DOCKET 50-155 - LICENSE DPR-6 -
BIG ROCK POINT PLANT - STATUS REPORT
REGARDING REVISIONS TO SPENT FUEL RACK
ADDITION - CONSOLIDATED APPLICATION

SUBJECT: BIG ROCK POINT
Spent Fuel Storage Expansion

FIGURE 2
 BIG ROCK POINT PLANT
 FIRE PROTECTION SYSTEM
 MAKEUP TO REACTOR
 AND SPENT FUEL POOL

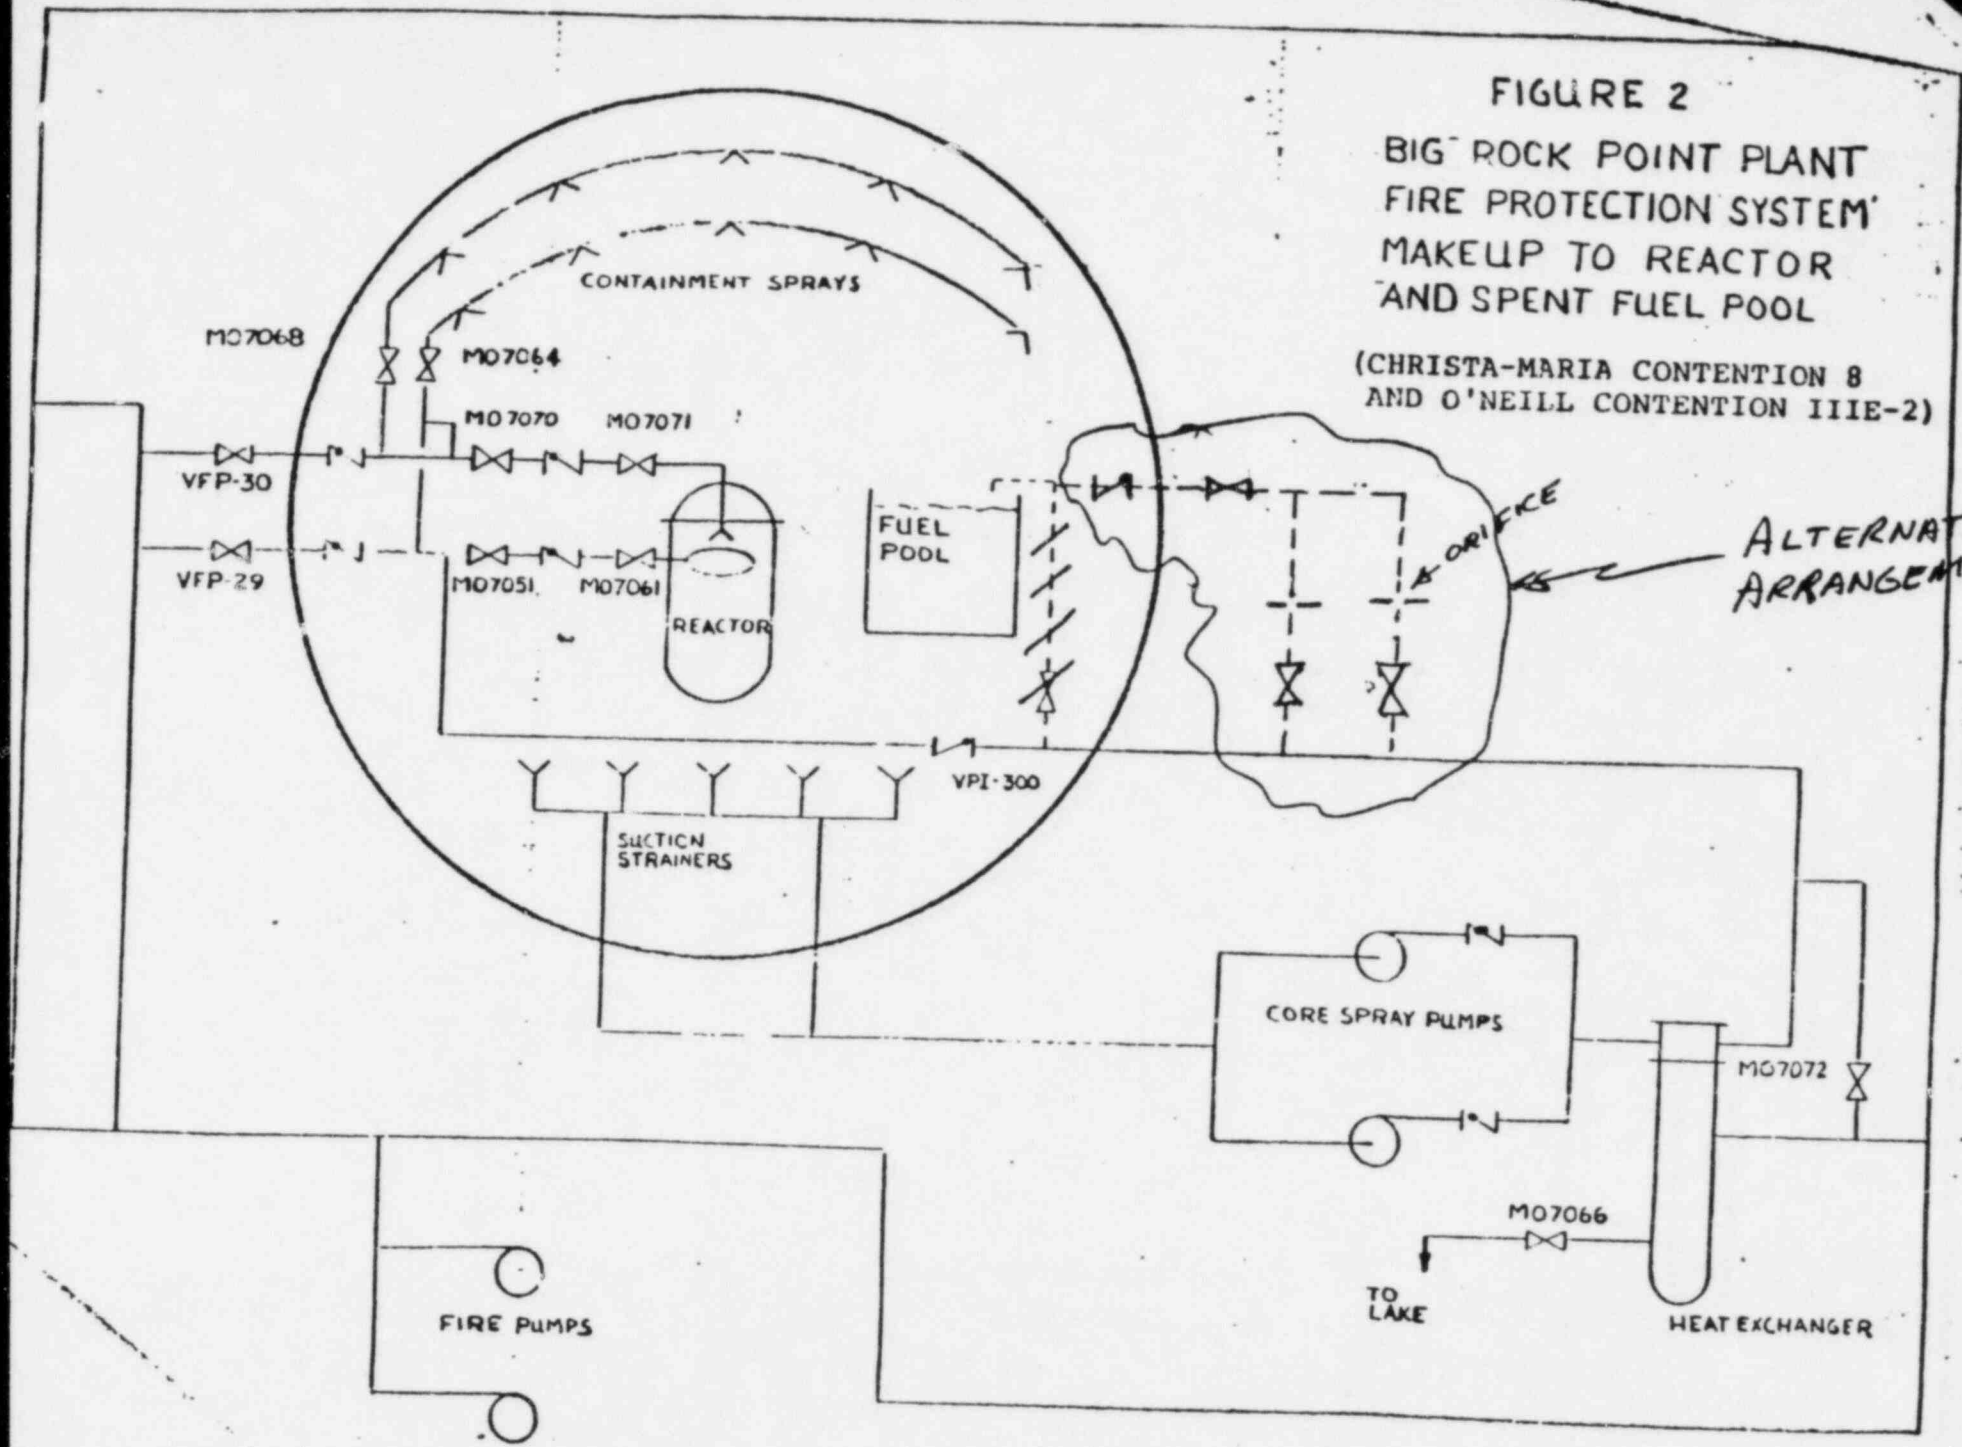
There is an opportunity to improve the safety of the existing facility. The connection to the spent fuel pool of the ECCS makeup line would provide a capability not now present. It could be made more effective by designing it so as to withstand a single failure challenge. The schematic shown in Blanchard's Figure 2 indicates a single line taken off the core spray header inside the containment for delivering a 2 gpm bypass flow to the pool. It is controlled by a single valve. I have calculated the size of the orifice required to restrict the pool flow to about 2 gpm and find it is quite small. Assuming a core spray header pressure of approximately 150 psig, the orifice (or throttled valve) would be only about 0.1 inch in diameter. Since this system would be used for the recirculation mode, there is a good chance that the coolant will contain a lot of dirt and debris. It would be partially protected by the core spray suction strainers, but 0.1 inch is a small hole and it could easily plug, making it non-functional. The solution would be to put in a redundant flow control path and to locate the valves and orifices outside the containment to assure operability. (See attached copy of marked-up Figure 2 for a possible improvement.) They would have to be properly designed as they would become part of the containment boundary, but that can be done if proper codes and standards are followed.
